ADDITIONAL S75W AMENDMENTS 27.05.20:

**PROPOSED MIXED USE DEVELOPMENT**

**47-50 THE ESPLANADE ETTALONG BEACH**

**AMENDED SUBMISSION**

**GROUND FLOOR PLAN**

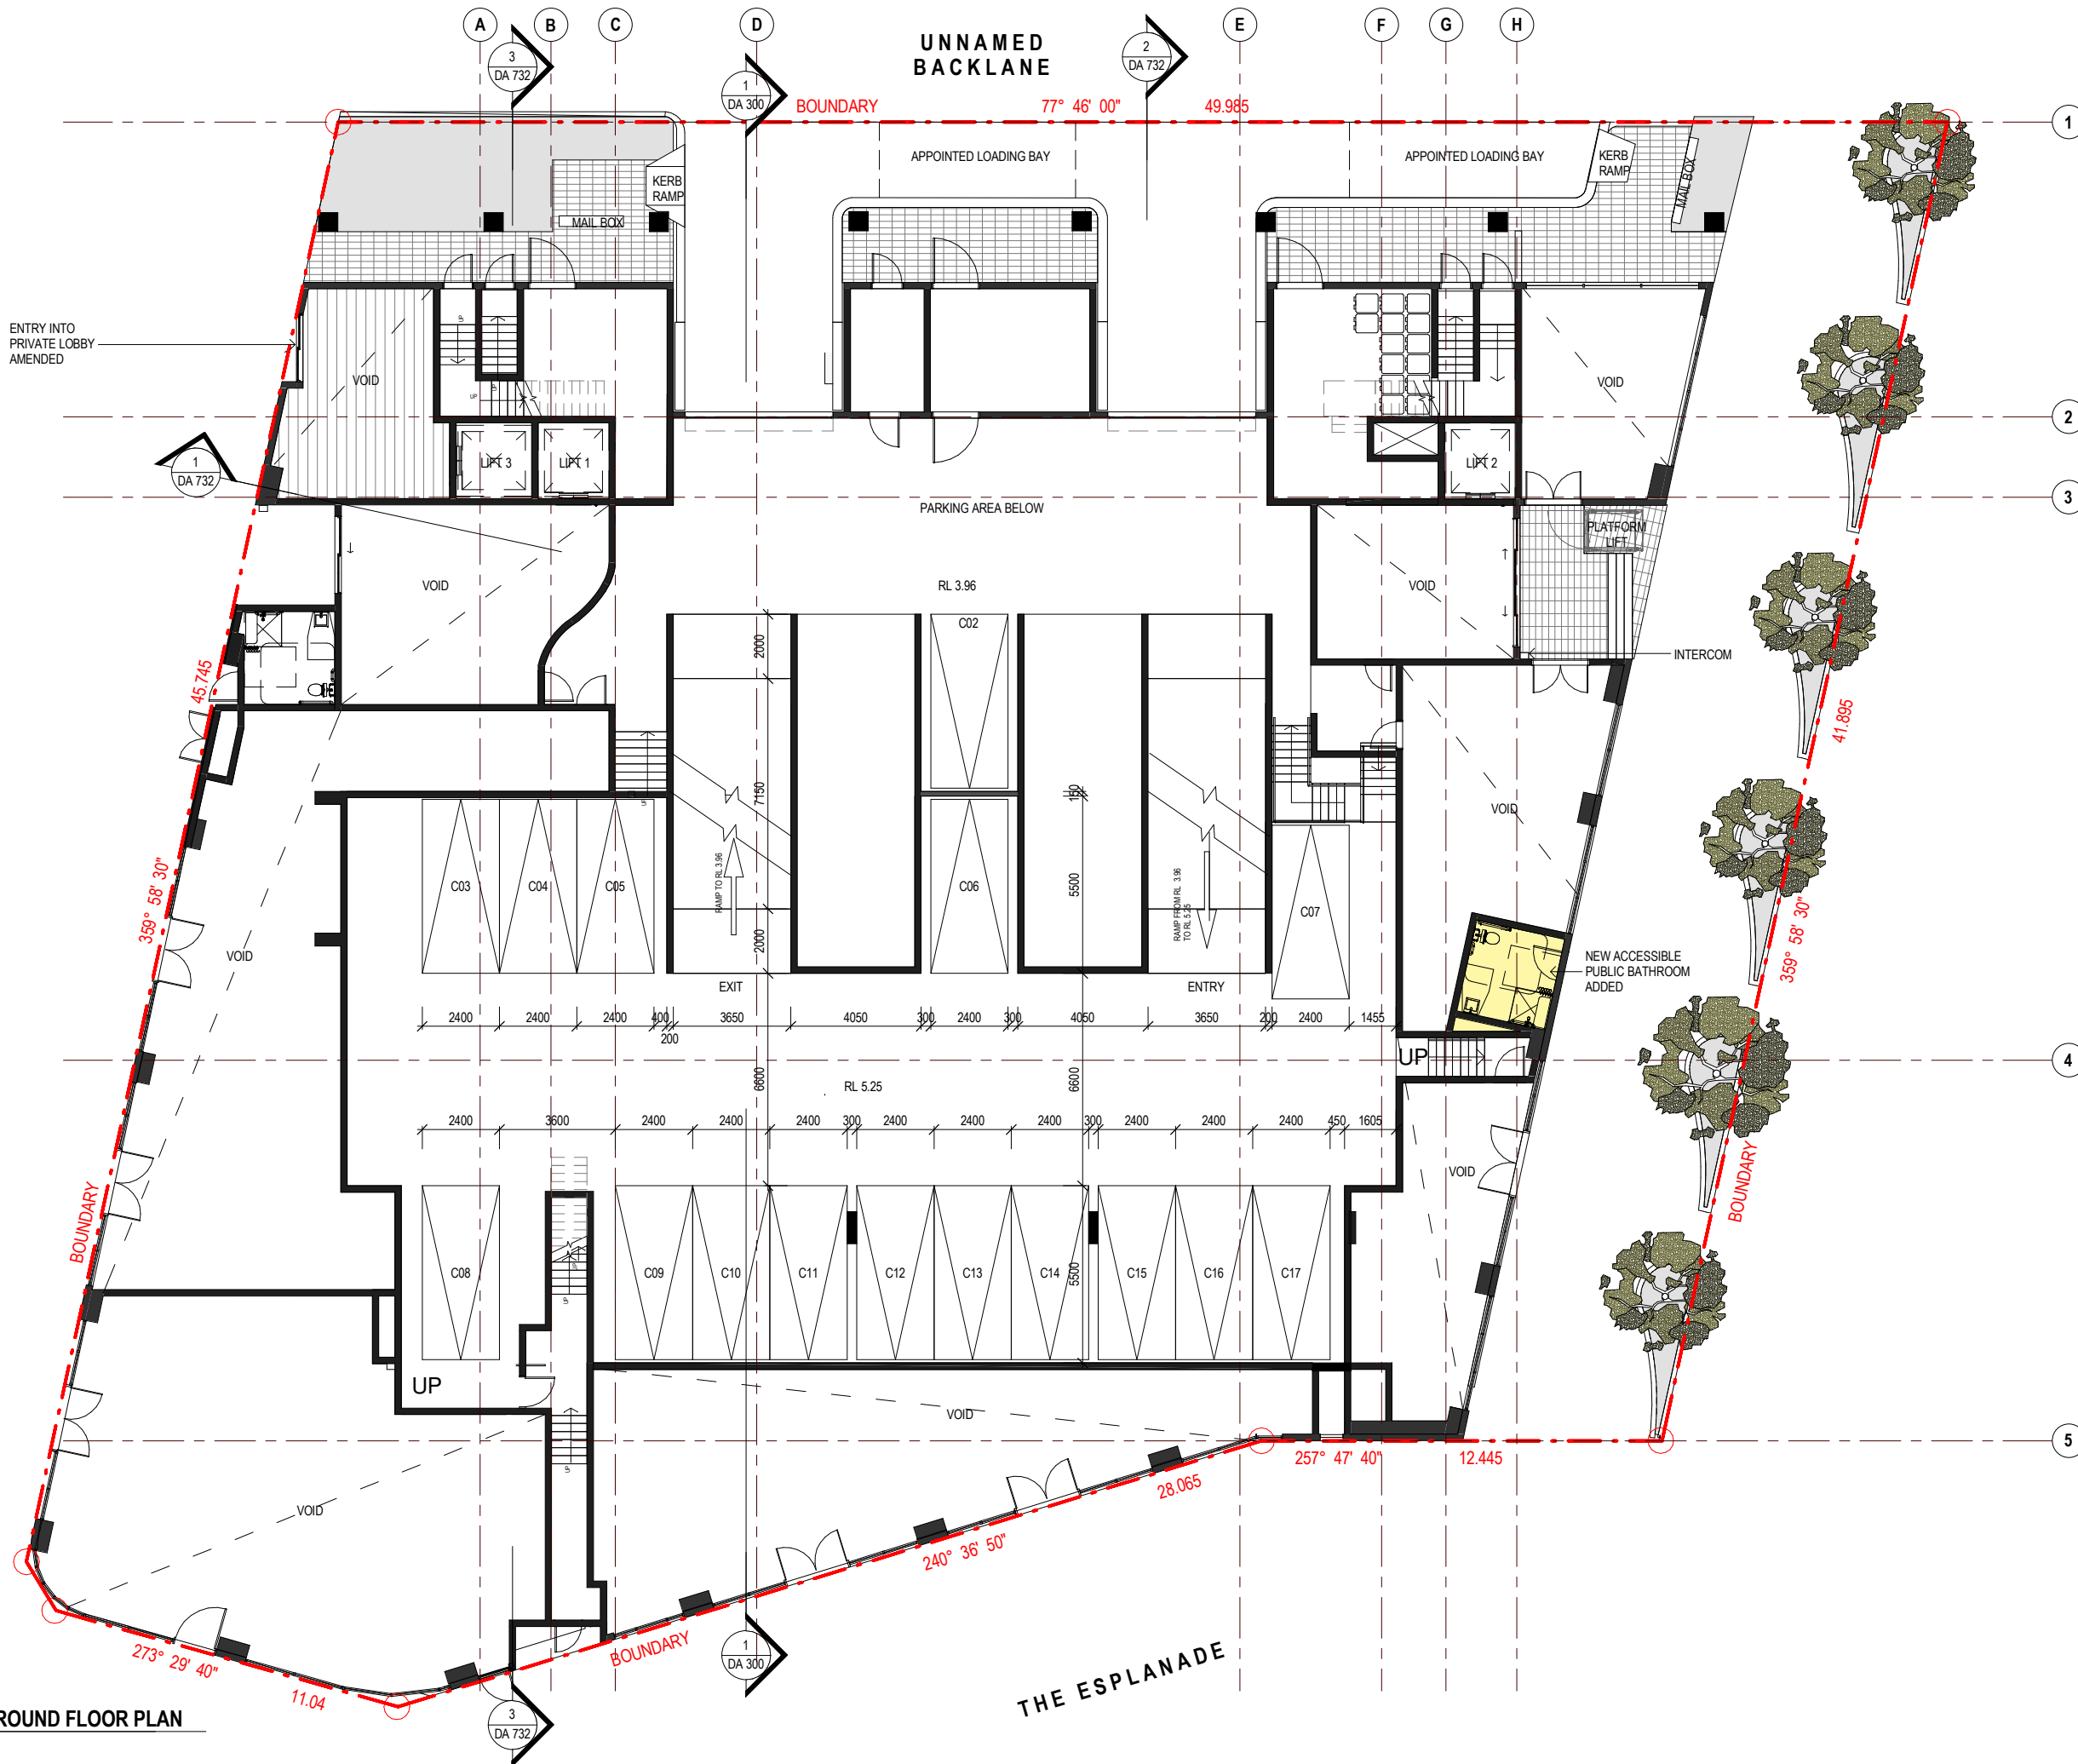
- NEW ACCESSIBLE PUBLIC BATHROOM ADDED

UPPER GROUND  
FLOOR PLAN (COMPARISON SHEET)

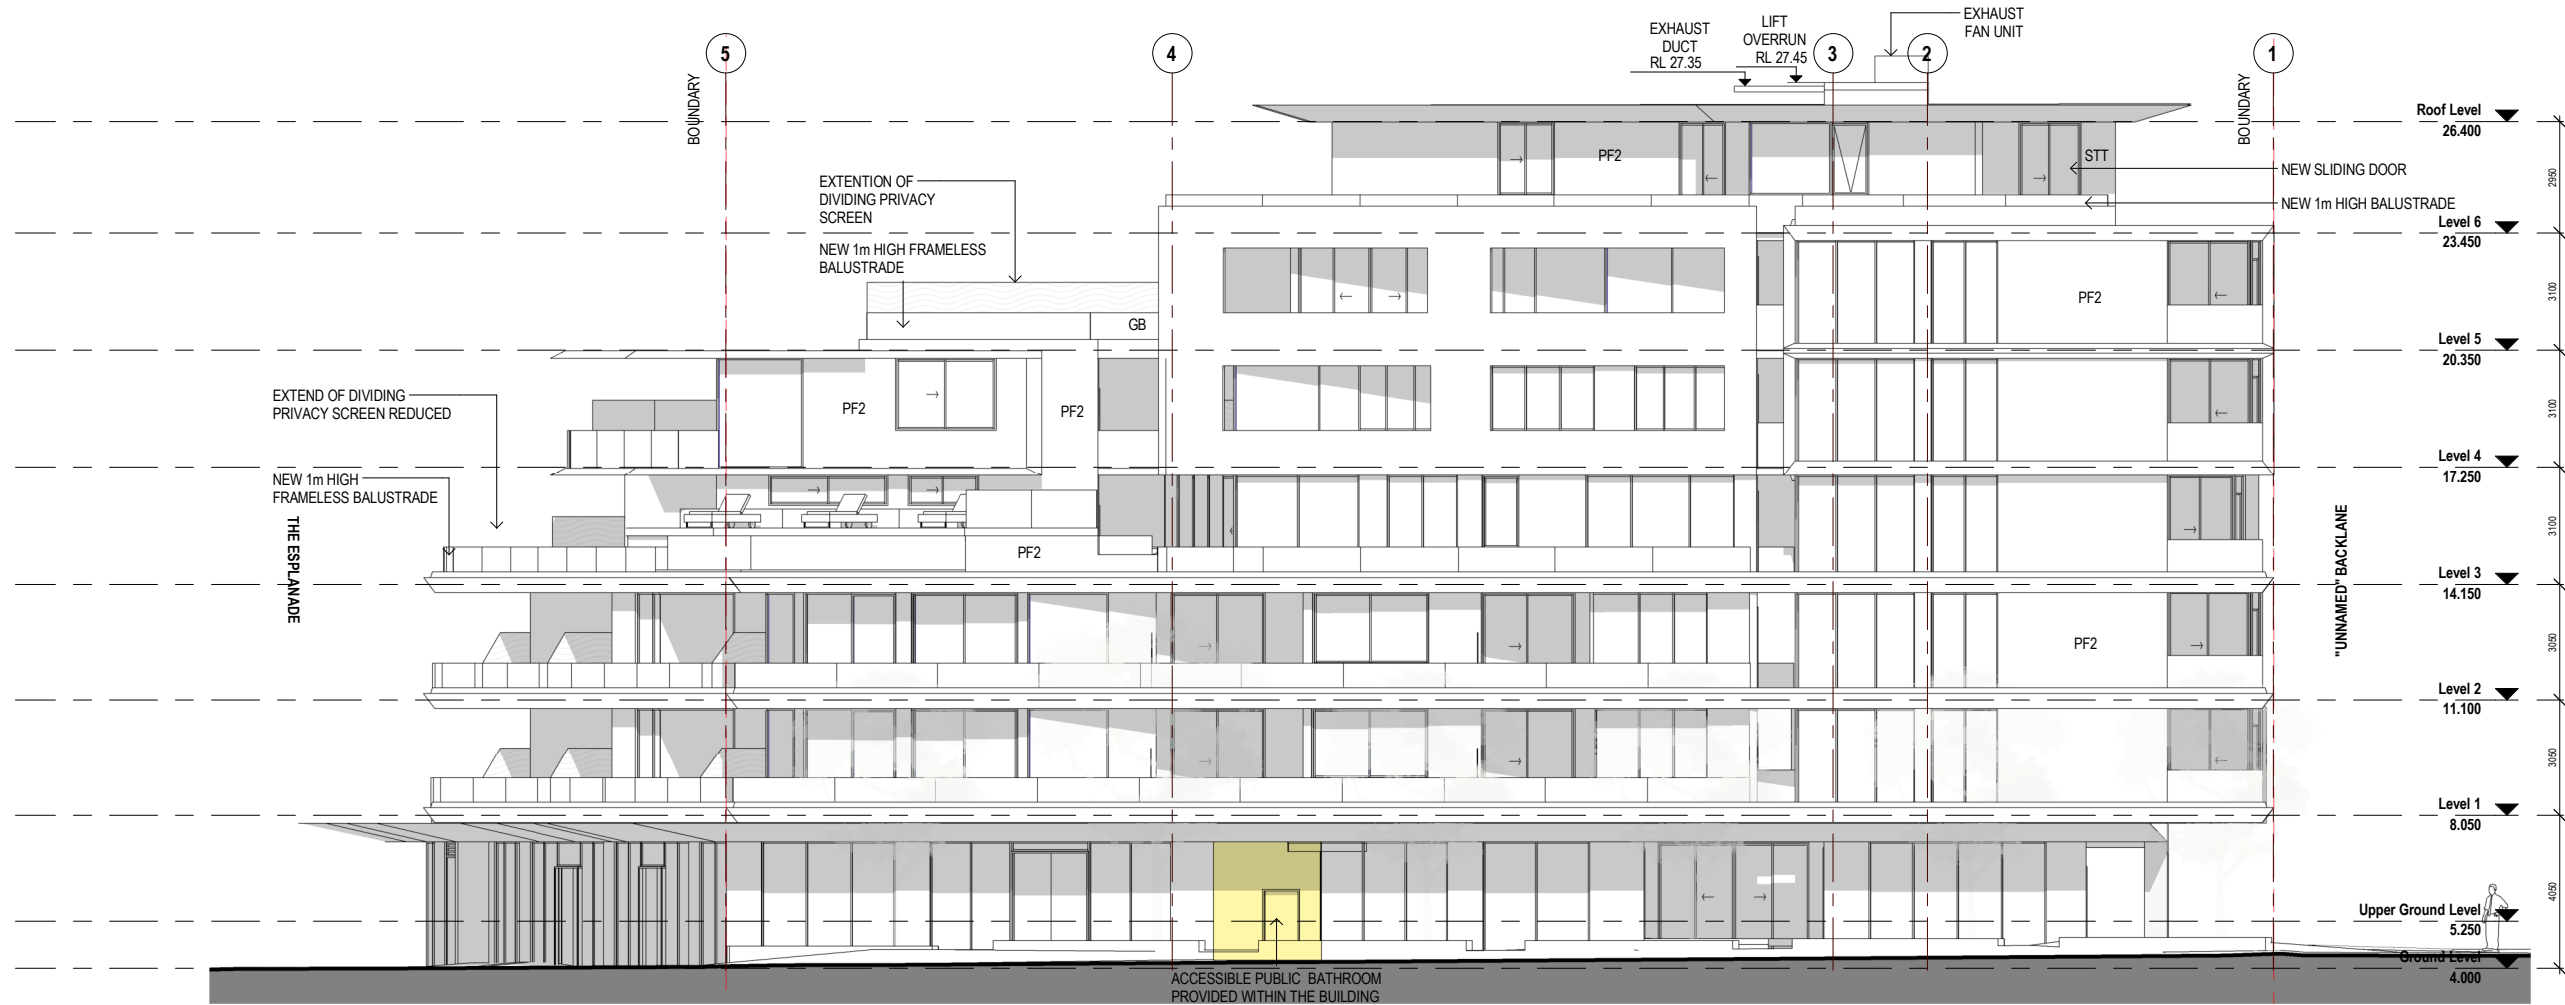
ADDITIONAL S75W AMENDMENTS 27.05.20:

- NEW ACCESSIBLE PUBLIC BATHROOM ADDED
